Solicitation Addendum

Addendum No.: 2
Solicitation No.: 17-2001OV
Project No.:
Solicitation Title: Chiller and Exhaust Fan Replacement at the Water Treatment Lab
Addendum Date: October 20, 2017
Procurement Contact: Olga Valcich olga.valcich@mymanatee.org

WATER TREATMENT LAB CHILLER & EXHAUST FAN REPLACEMENT CONSTRUCTION DOCUMENTS

SHEET NUMBER
CH-M1.1
 BID SET

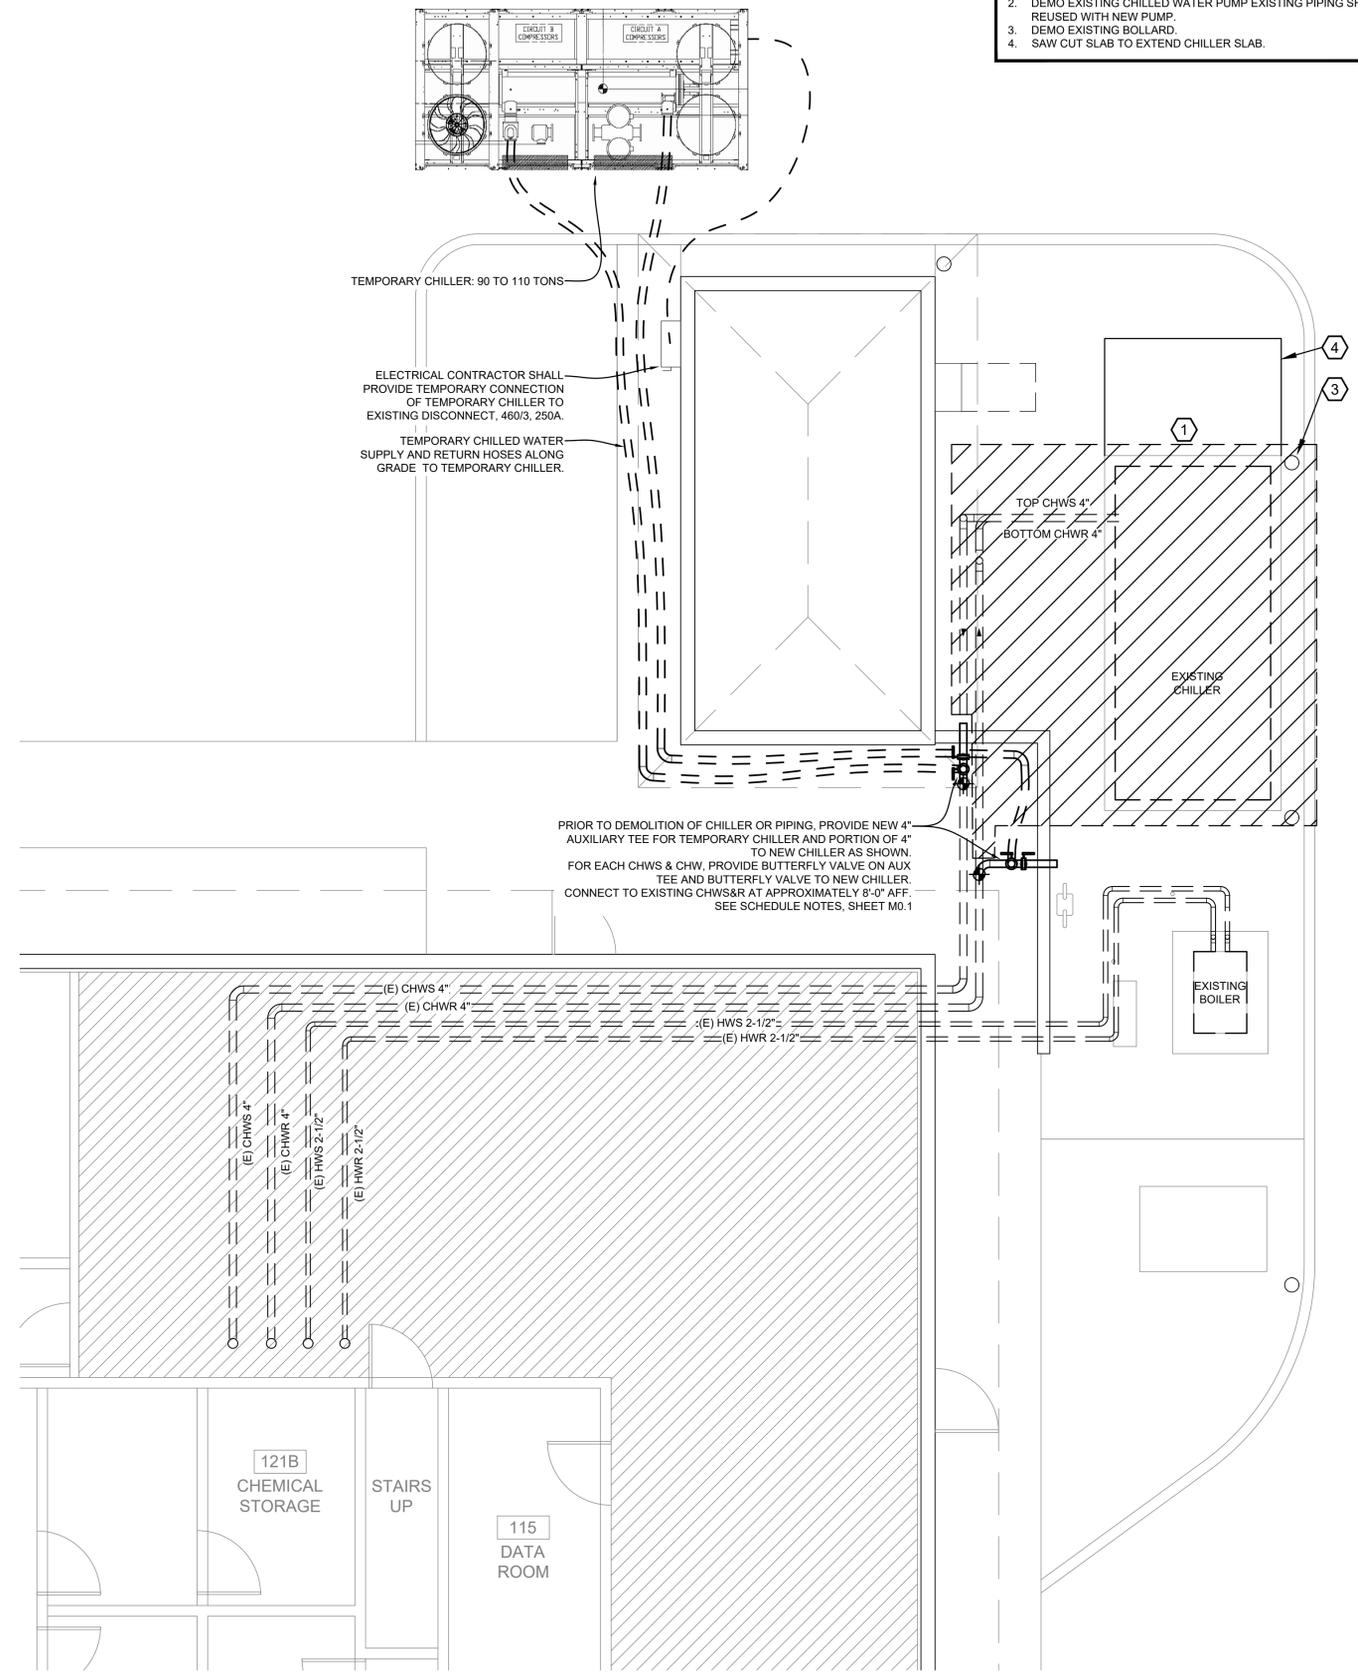
Q1. On print CHM1.1 note 4 'saw cut slab to extend chiller pad'. Are we matching the existing 1" chiller pad?

R1. Chiller Pad: The top of the existing chiller pad is about one inch above the surrounding concrete, however, the concrete goes down much deeper than that. Per 1998 As-Built Drawing, C8.0, the pad should be 12" deep along the perimeter and 6" deep in the middle. There is no way to know how it was built until ground is broken. For the pad extension, refer to detail 9, Sheet Ch-M3.2.

SHEET NUMBER
CH-M2.1
 BID SET

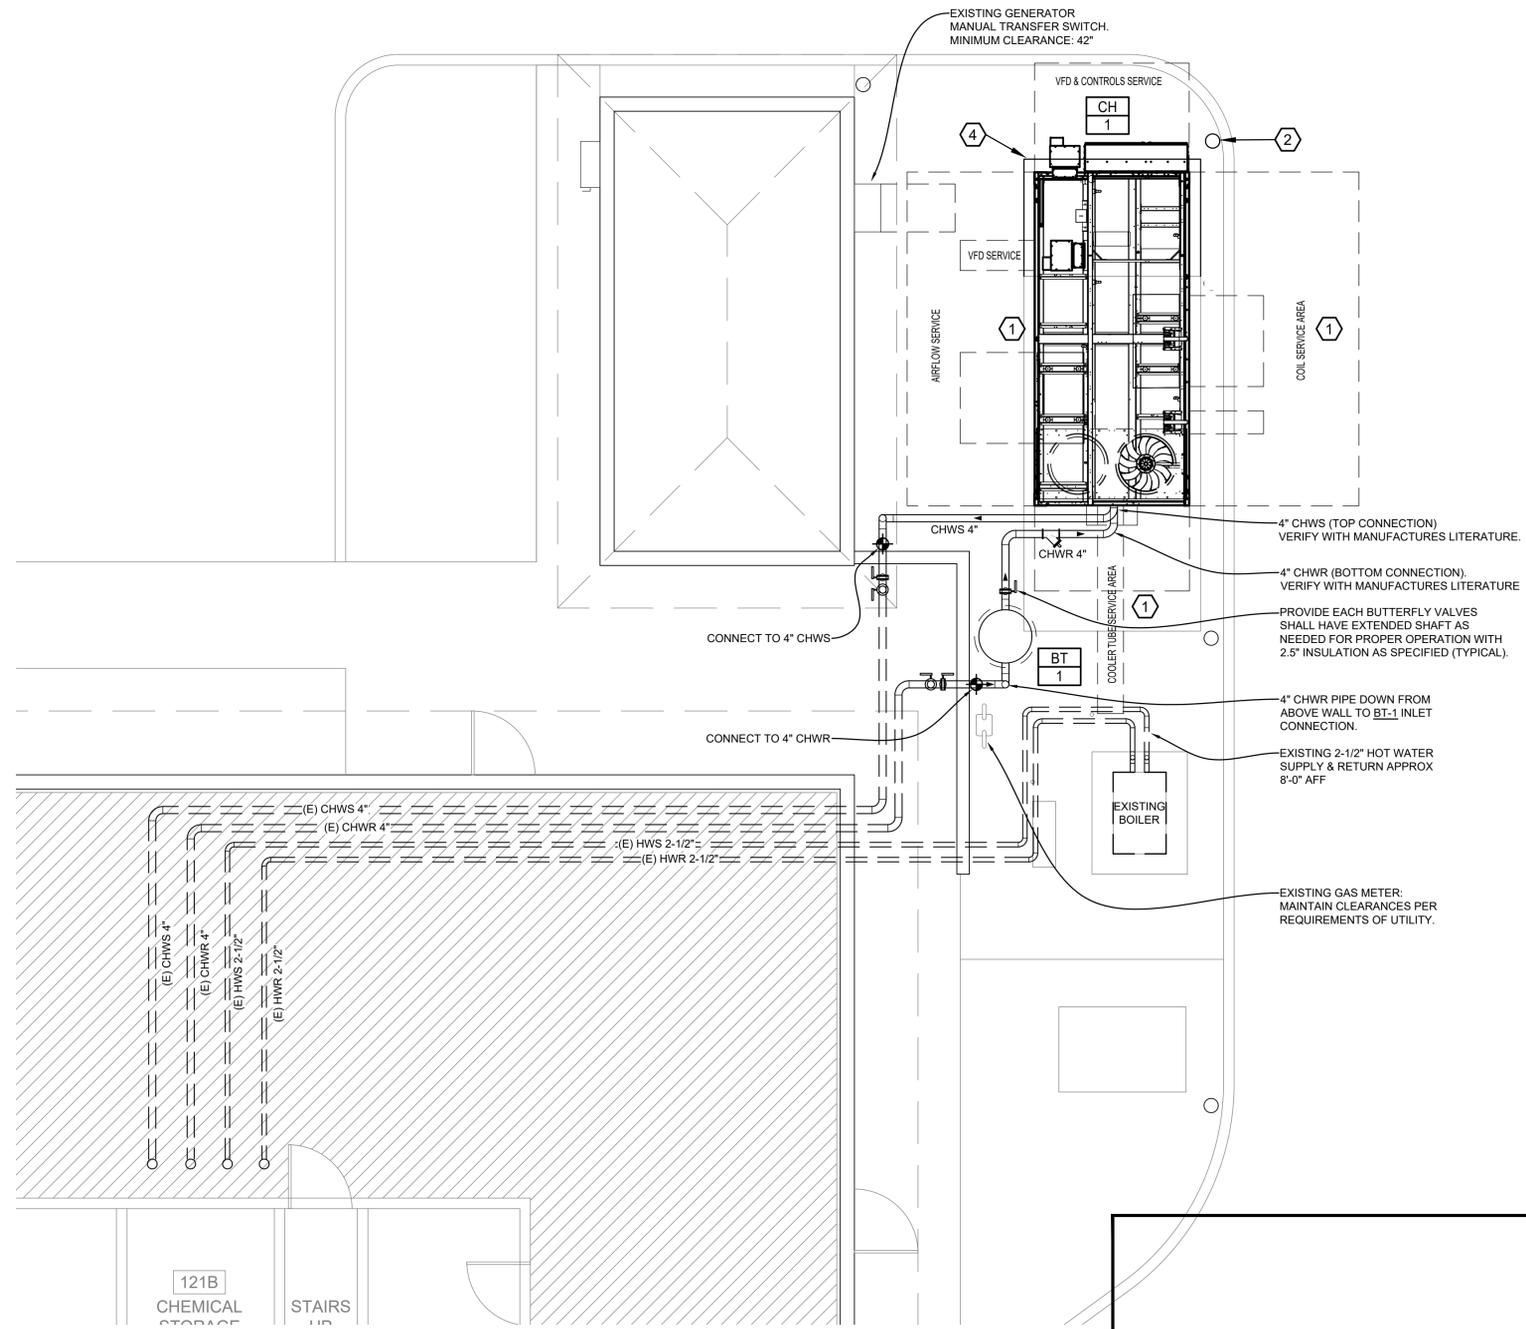
Q2. On print CHM2.1, states to flush system and fill with glycol. I believe this is a regular chiller water system. Can we clarify? In addition, who is the Water Treatment Company the County is currently using.

R2. Currently the system is filled with water. At the end of this chiller change-out, it is to be 15 percent ethylene glycol as per plans. Chiller controls to be configured for glycol mix per control notes so that the County may reset the temperature down lower in the future if operations call for it. The County currently has a Blanket Purchase Order for water treatment with Kibler Chemical Corp., St. Cloud, FL (407) 738-7732 which is valid through January 31, 2018.

SHEET NUMBER
EF-E1.0
 BID SET

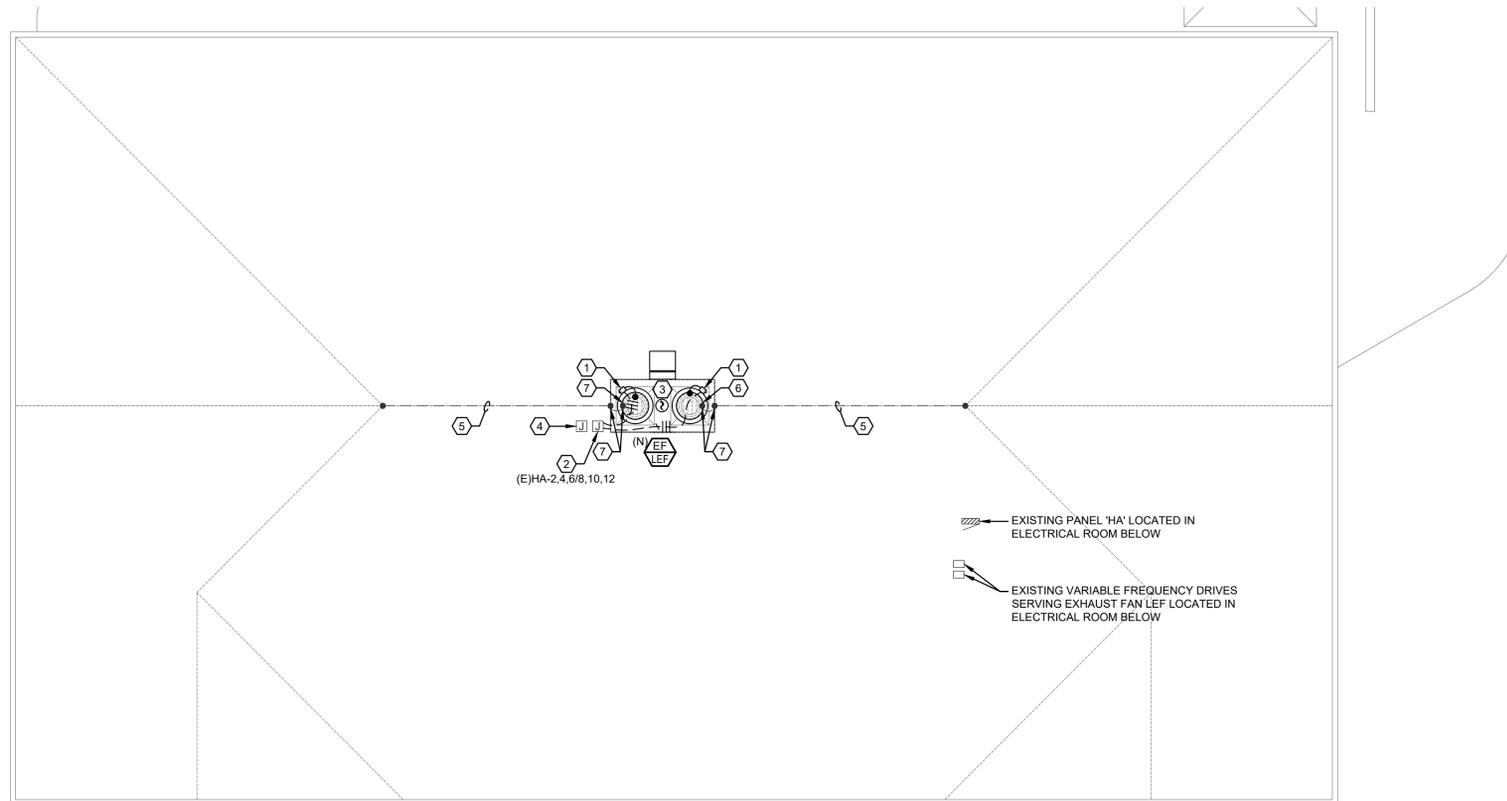
Q6. Please provide the name of the Fire Alarm Company utilized at the Lab to disconnect and reconnect the Fire Alarm Smoke Detector for the Exhaust Fan replacement as required per Plan Sheet No. EF-E1.0.

R6. The name of the Fire Alarm Company is Electronic Protection Systems, located in Bradenton, FL, (941) 749-0717.
